[Docket No. 2001-SW-39-AD; Amendment 39-12751; AD 2002-10-05]

Airworthiness Directives; MD Helicopters Inc. Model MD-900 Helicopters

ACTION: Final rule.

Figure 1. Main Rotor Upper Hub Assembly Inspection

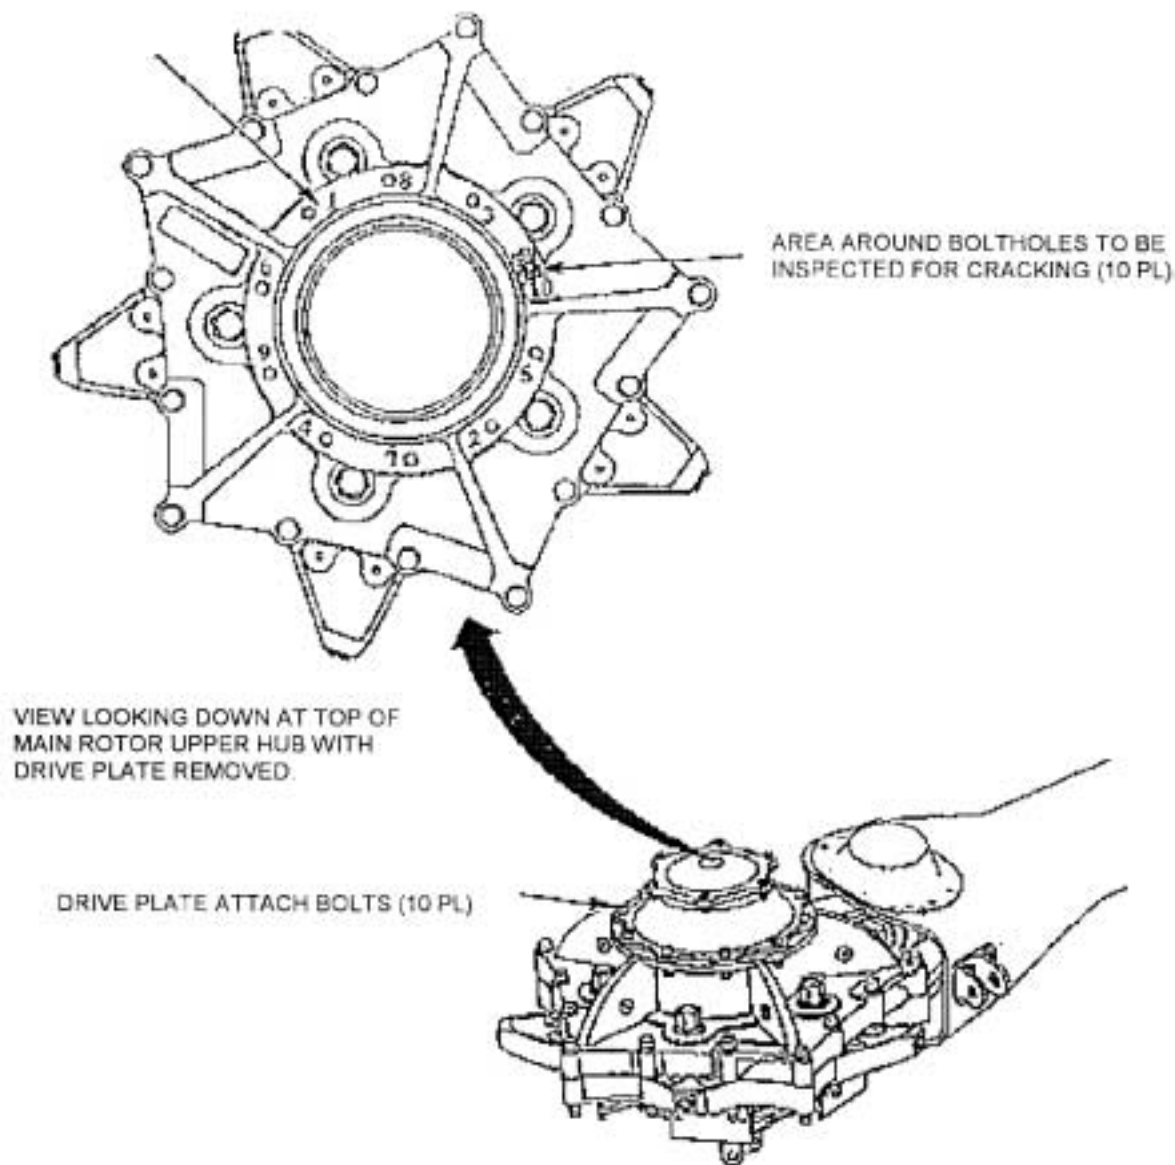
(ii) Mark the main rotor hub holes to correspond with the drive plate hole numbers (see Figure 1 of this AD).

(v) Using paint stripper (Consumable Item List C313 or equivalent) and cleaning solvent (C420 or equivalent), remove the paint from the upper mating surface of the hub assembly to enable an accurate visual inspection of each drive plate attachment bolt hole (bolt hole) area for cracking (Figure 1). Ensure the paint stripper and solvent DO NOT contaminate the upper bearing and upper grease seal areas.

(viii) Reinstall the main rotor drive plate using 10 new sets of replacement attachment hardware. Torque the nuts to 160 inch pounds above locknut locking/run-on torque in the sequence shown (Figure 1). Record in the rotorcraft logbook, or equivalent record, the locknut locking/run-on torque for each nut.
